RELAY K9 SOLID STATE CONVERSION

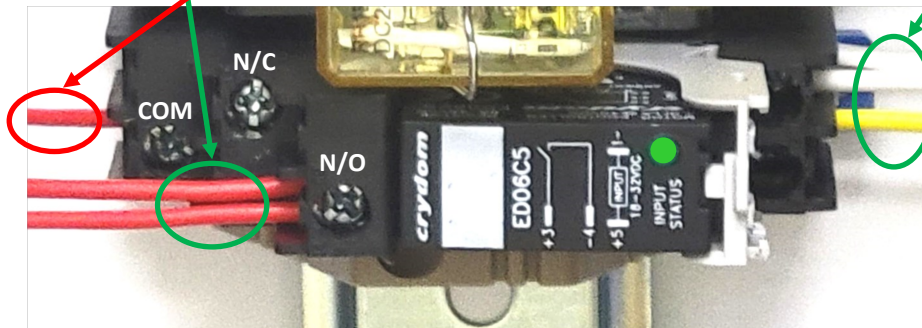
Relocate both red wires to the top connector 'N/O' of solid state relay socket base.

If the yellow and two white wires are connected as shown, they must be **reversed** for solid state use.

Relocate this red wire to the left bottom connector of solid state relay socket base. 'COM'

Yellow wire must be below white wires
